Access Compliance Report

Public Rights-of-Way

(Curb Ramps)

Intersection ID: 13736	Main Street: CAMDEN_RD	Cross Street: E_PARK_AV	Location:	N
ADA ID: 0EFEE16D153D	Ramp Type: PerpDiag	Initial Pass/Fail: Fail	Overall Compliance: No	Severity Score: 1.25

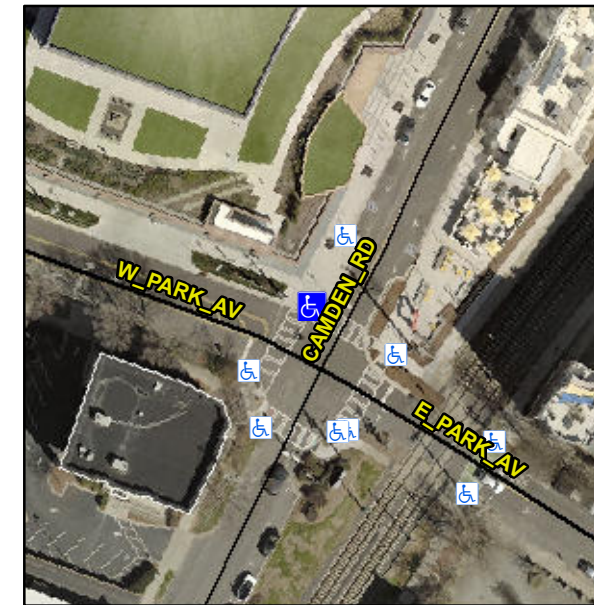
R304.5.3

Compliance	Description	Data	Compliance	Description	Data
N/A	Ramp Length (in)	88.0	Yes	Ramp Slope (%)	5.4
Yes	Ramp Width (in)	61.0	No	Ramp XSlope (%)	2.2
N/A	Flare Type LT	N/A	N/A	Flare Type RT	N/A
N/A	Flare Slope LT (%)	N/A	N/A	Flare Slope RT (%)	N/A
N/A	Flare Traversable LT?	N/A	N/A	Flare Traversable RT?	N/A
N/A	Landing Length (in)	N/A	N/A	DWS Provided?	N/A
N/A	Landing Width (in)	N/A	N/A	DWS Contrast?	N/A
N/A	Landing Slope (%)	N/A	N/A	DWS Length (in)	N/A
N/A	Landing X Slope (%)	N/A	N/A	DWS Full Width?	N/A
N/A	Landing Curb? (Y/N)	N/A	N/A	DWS Offset (in)	N/A
N/A	Shared Landing?	N/A			
N/A	Gutter Ponding?	N/A	N/A	Gutter Slope (%)	N/A
N/A	Gutter Lip Ht (in)	N/A	N/A	Gutter X Slope (%)	N/A
N/A	Painted X Walk1?	Yes	N/A	Painted X Walk2?	Yes
	X Walk 1 Direction	To SW		X Walk 2 Direction	To SE
N/A	X Walk 1 Width (in)	111.0	N/A	X Walk 2 Width (in)	113.0
	X Walk 1 Slope (%)	0.1		X Walk 2 Slope (%)	1.6
	X Walk 1 X Slope (%)	1.9		X Walk 2 X Slope (%)	0.9

Remove & Replace Curb Ramp With Two New Directional Ramps or Equivalent.
